BID
ADDENDUM NO. 4
TO
CONTRACT DOCUMENTS
AND
TECHNICAL SPECIFICATIONS
FOR
2019 BOND REFERENDUM
CAPITAL IMPROVEMENTS
AT
MAMARONECK HIGH SCHOOL
PHASE 2
NYSED #66-07-01-03-0-001-039
BID # 20/21 – MUFSD-00

Mamaroneck Union Free School District
1000 West Boston Post Road
Mamaroneck, NY 10543

LAN Job #4.1092.72.06
January 13, 2022

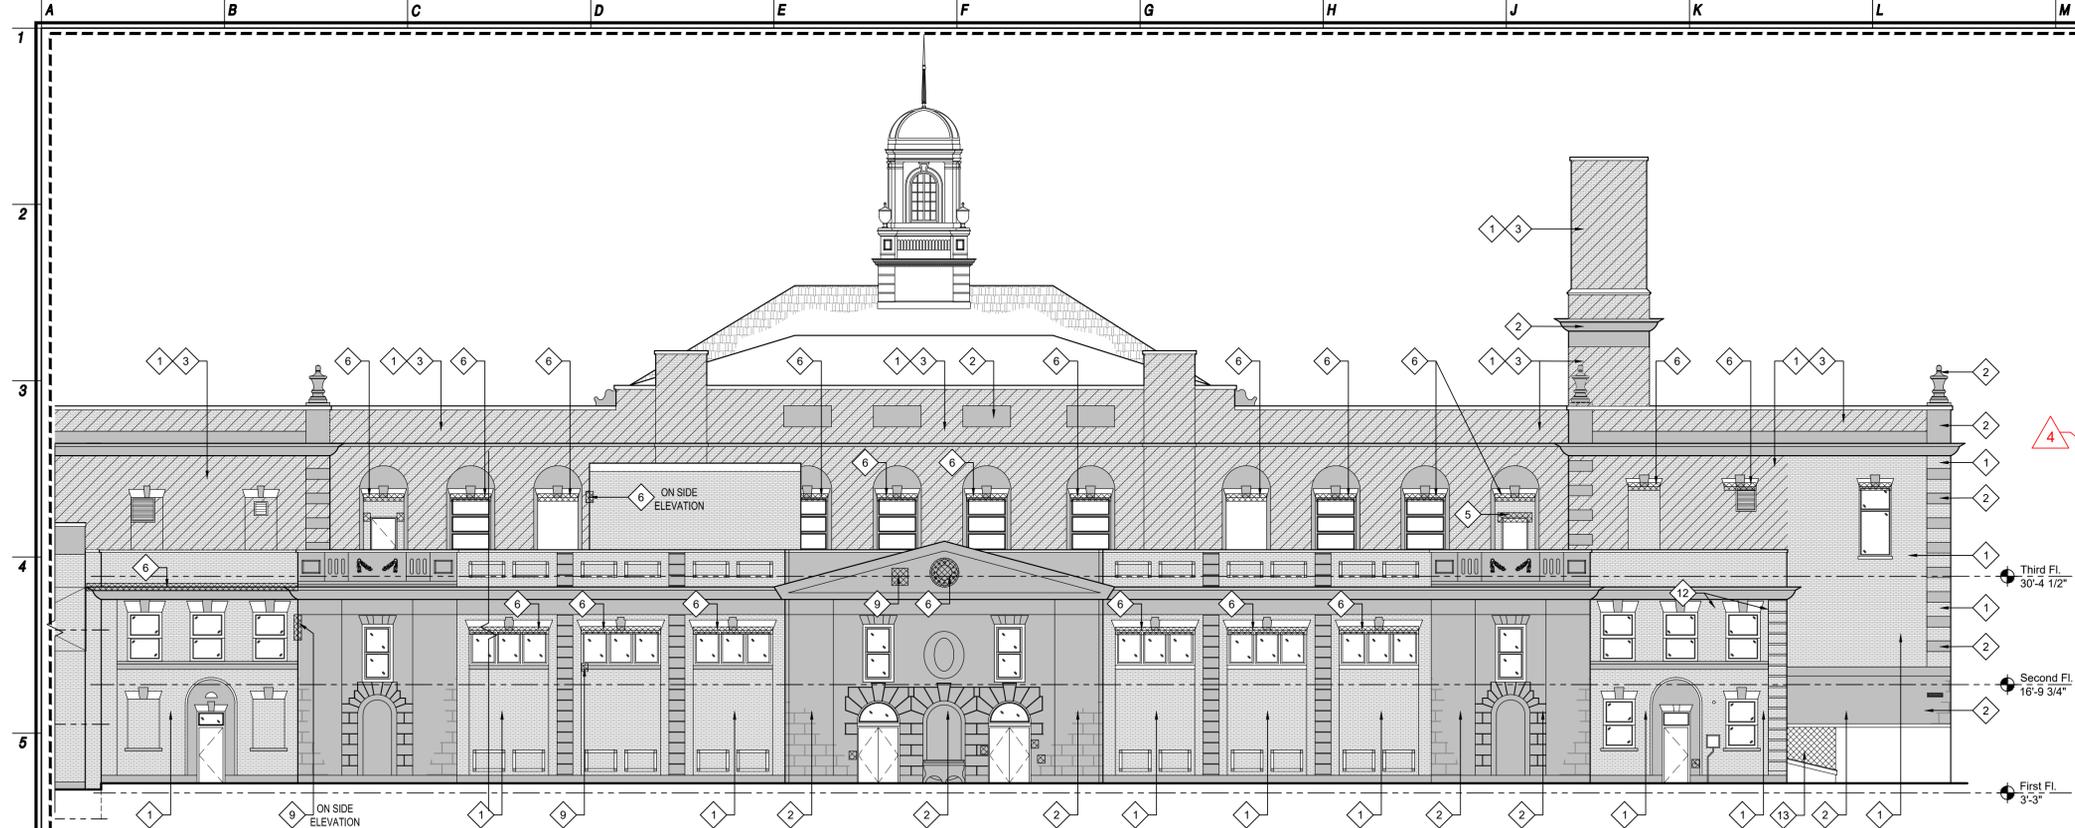
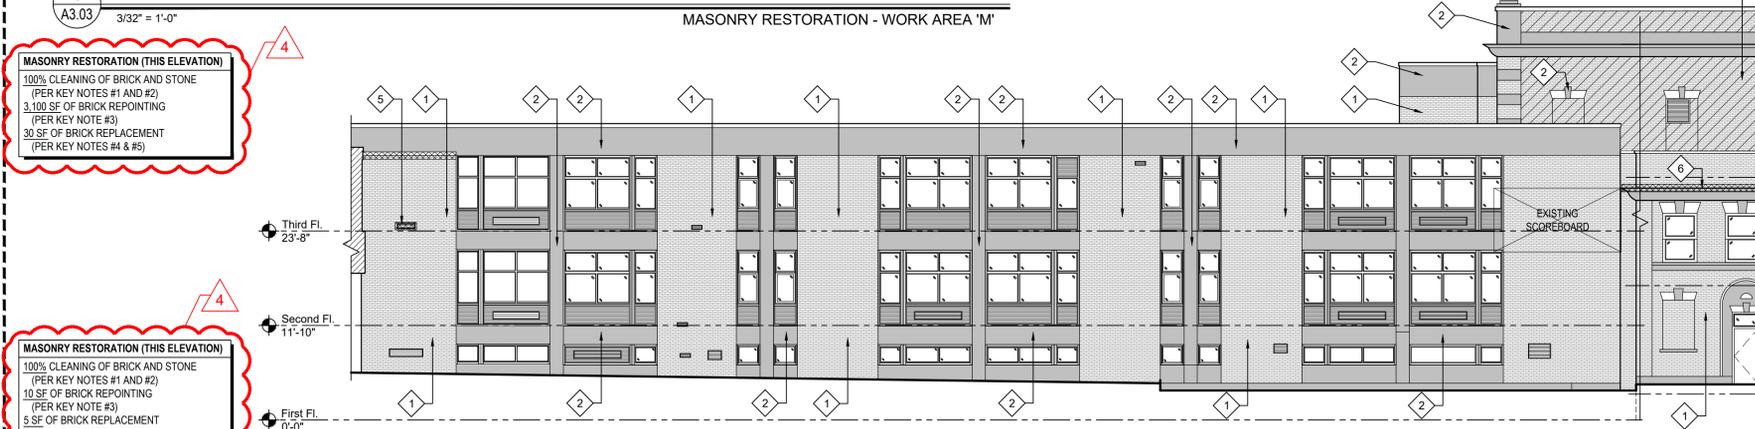
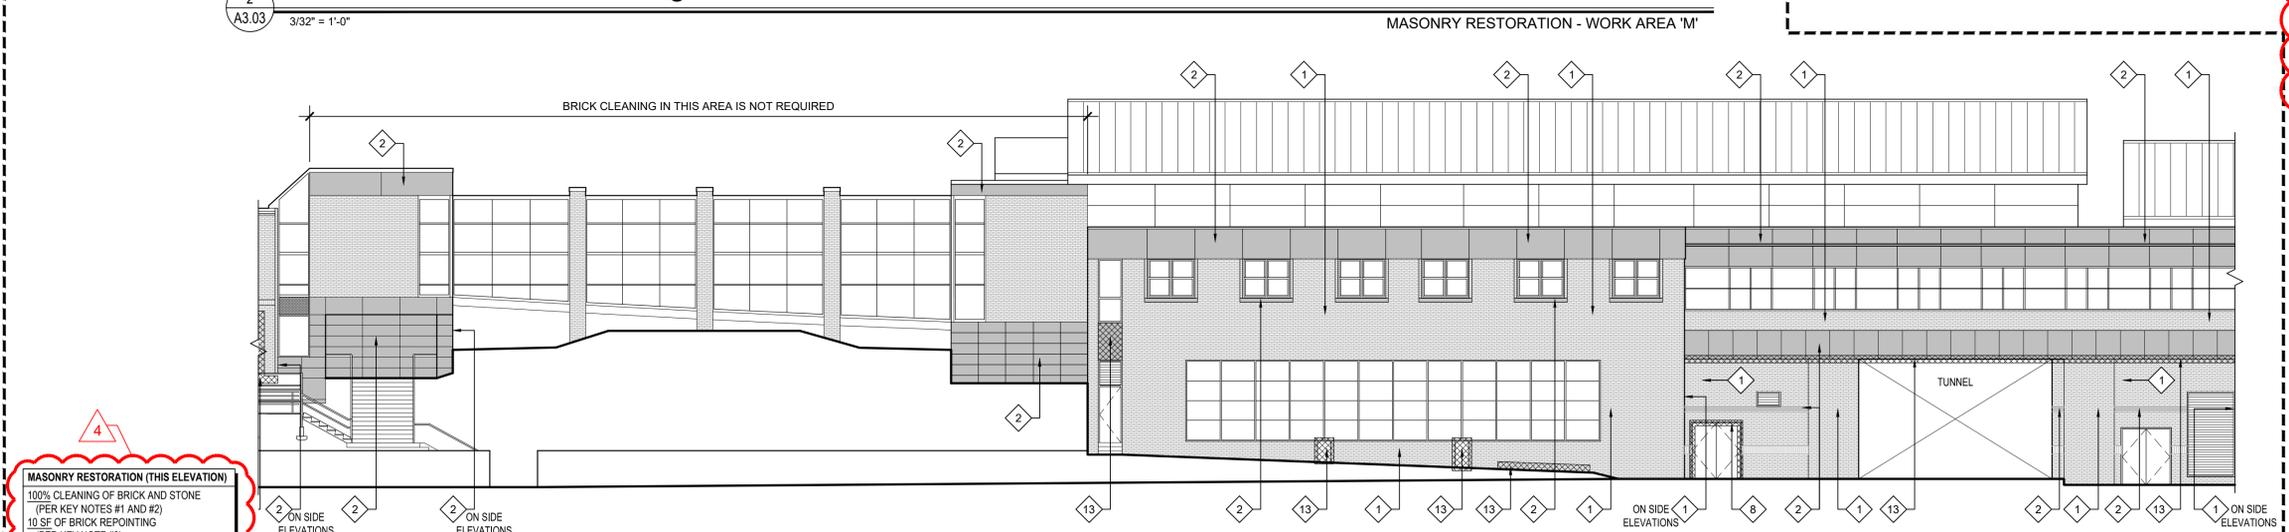
Drawing No.	Addendum Requirements
A2.01	Notes for Work Area 'A' revised to add note #73.
A3.01 – A3.08	Drawings revised to reflect masonry restoration percentages and square footages for bidding purposes. Symbol Legend on Drawing A3.03 was also updated. Drawings A3.03, A3.07 and A3.08 were revised to reflect re-glazing of select windows as identified on the plans.
A7.11	Drawing 3/A7.11 revised to add vinyl locker numbering to new metal lockers.
M1.11	Drawing revised to add Key Note #8.
M2.11	Drawing revised to show scope regarding the louver for MAU-1.

- 7 Question: Following note #4 from Symbols Legends DWG A3.03, "Area of sand/limestone/stone to be cleaned, repaired and/or repointed." Please advise a percentage of repairs and percentage of pointing.

- Response: Masonry scope of work has been clarified per revised Elevation Drawings A3.01 – A3.08. Symbol Legend on Drawing A3.03 was also updated.

BOILER ROOM DEMOLITION PLAN
 CAPITAL IMPROVEMENTS AT
 MAMARONECK HIGH SCHOOL
 MAMARONECK UNION FREE SCHOOL DISTRICT
 1000 BOSTON POST ROAD, MAMARONECK, NY 10543

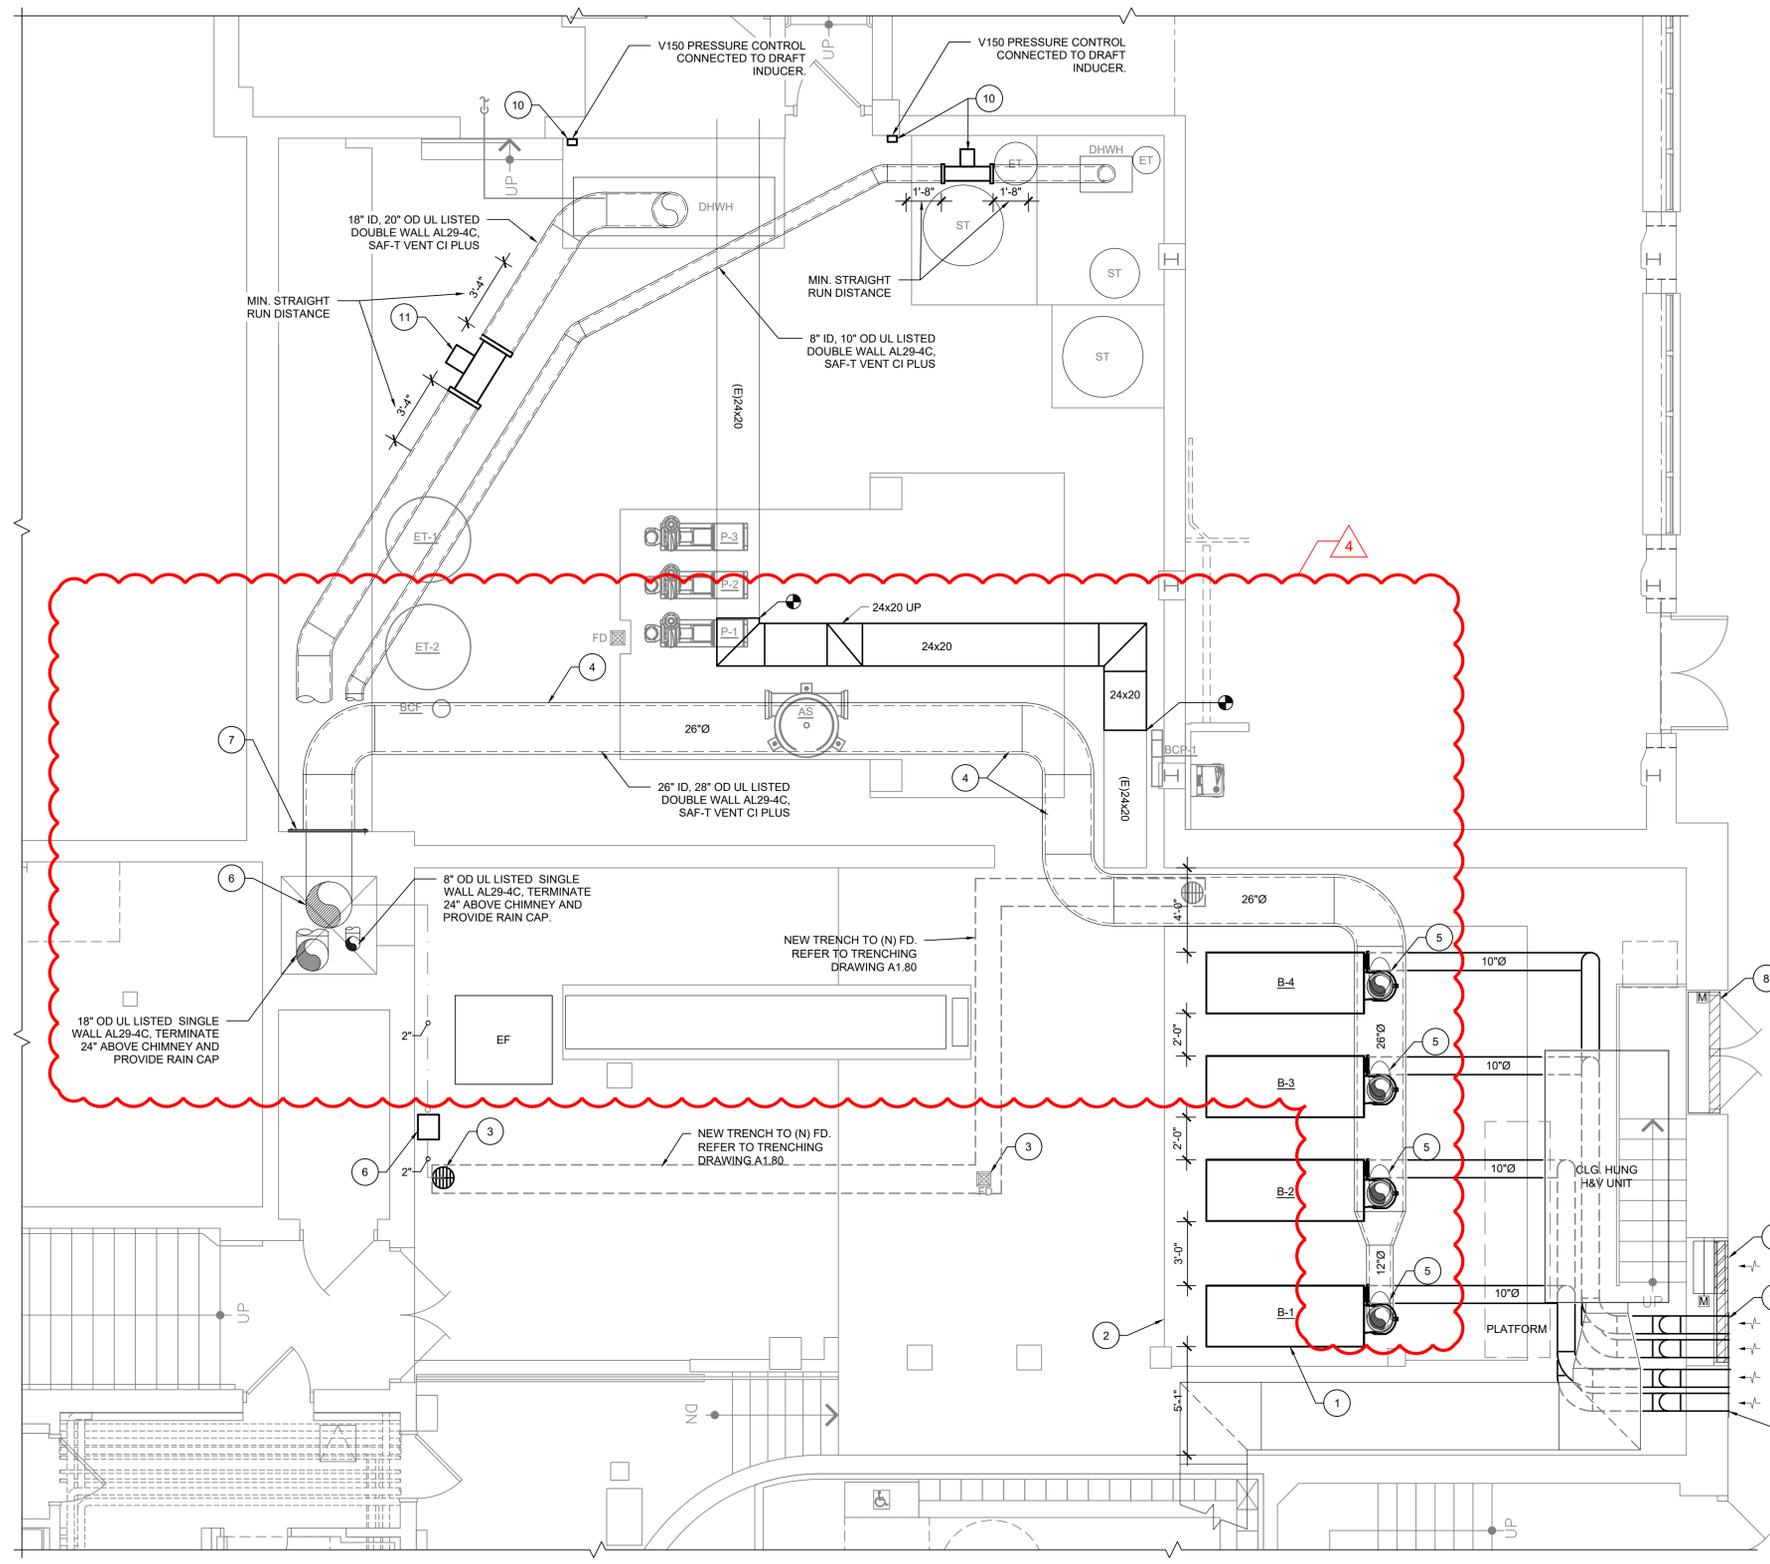
Drawing No.	Addendum Requirements
M1.81	<p>Drawing revised to show section of the existing exhaust ductwork to be disconnected and removed.</p> <p>Drawing revised to add Key Note #15.</p>
M2.82	<p>Drawing revised to show the rerouting of boiler room breeching/flue and the new routing of the exhaust ductwork.</p>
E1.10	<p>The first note in the "Fire Alarm Demolition Notes" have been revised to read:</p> <ul style="list-style-type: none">• FIRE ALARM SYSTEM IS UNDER WARRANTY AND AS SUCH, ALL FIRE ALARM MODIFICATIONS SHALL BE PERFORMED BY THE FIRE ALARM VENDOR HOLDING THE WARRANTY AS PART OF THE FIRE ALARM ALLOWANCE. <p>This drawing is not being reissued.</p>
E1.20	<p>The first note in the "Fire Alarm Demolition Notes" have been revised to read:</p> <ul style="list-style-type: none">• FIRE ALARM SYSTEM IS UNDER WARRANTY AND AS SUCH, ALL FIRE ALARM MODIFICATIONS SHALL BE PERFORMED BY THE FIRE ALARM VENDOR HOLDING THE WARRANTY AS PART OF THE FIRE ALARM ALLOWANCE. <p>This drawing is not being reissued.</p>

- 3 Question: Please refer to Contract Drawing M1.81 and M2.82 for the boiler room breeching. The routing shown for the new boiler breeching conflicts with existing conditions and may conflict with switchgear and electrical panel clearances. At the walkthrough it was discussed reusing the routing of the existing breeching above the switchgear. Please advise if this is acceptable. Please also advise if the mechanical contractor will be required to provide protection above the switchgear during construction, if so what type of protection is required.

- Response: Refer to revised drawings M1.81 and M2.82 for boiler room breeching. All prime contractors are responsible to protect existing equipment adjacent to their work from damage during construction.
